REMARKS

Application No.: 10/756,858
Response to Office Action of 03/21/2005
Attorney Docket: Norte-523A

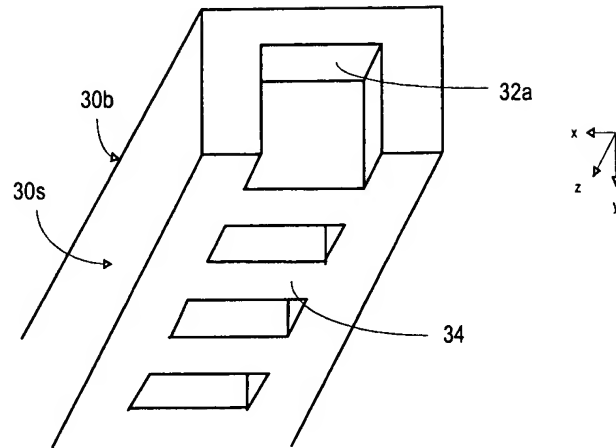
The Examiner objected specification and indicated that in paragraph [0022], it is unclear as to how the applicant is defining "ridge" and "trench". The Examiner suggested that ridge "32" should be changed to --34-- and trenches (i.e. hollow portion) "34" should be changed to --32-- (see fig. 4).

The Applicant respectfully traverses the objection because definitions of the ridge 32 and the trench 34 are relative terms depending on the viewing direction and the reference point/object. For example, when one observes the slow-wave structure 10 in a reversed direction as shown in the following drawing, the ridge and trench behaviors of 32 and 34 can be easily seen.

Fig. 3

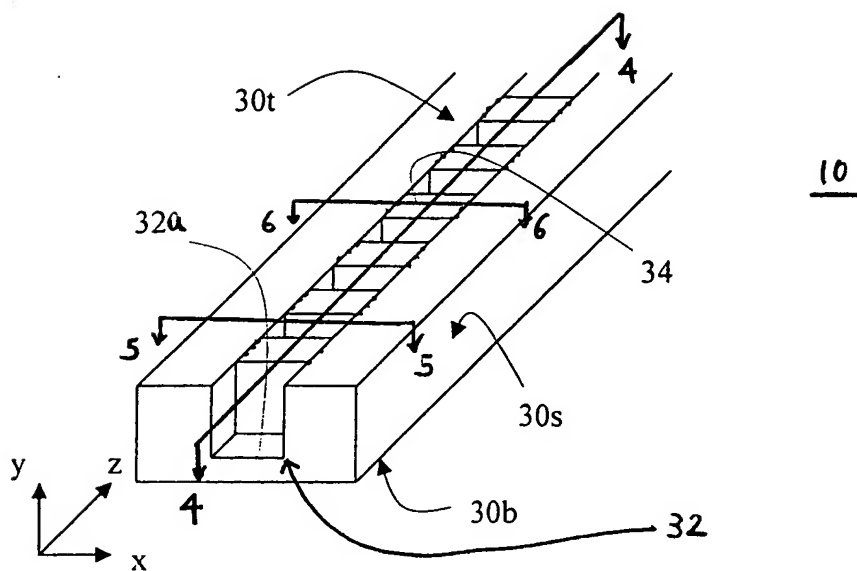
Figure 3 has been amended to overcome the objection.

In Figure 3, numeral references 10 and 32a have been added to indicate the slow-wave structure of the ridge waveguide and the ridge segments, respectively. In addition, the cutting lines 4-4, 5-5 and 6-6 along which the cross sectional views are taken as shown in Figures 4, 5 and 6 are added.
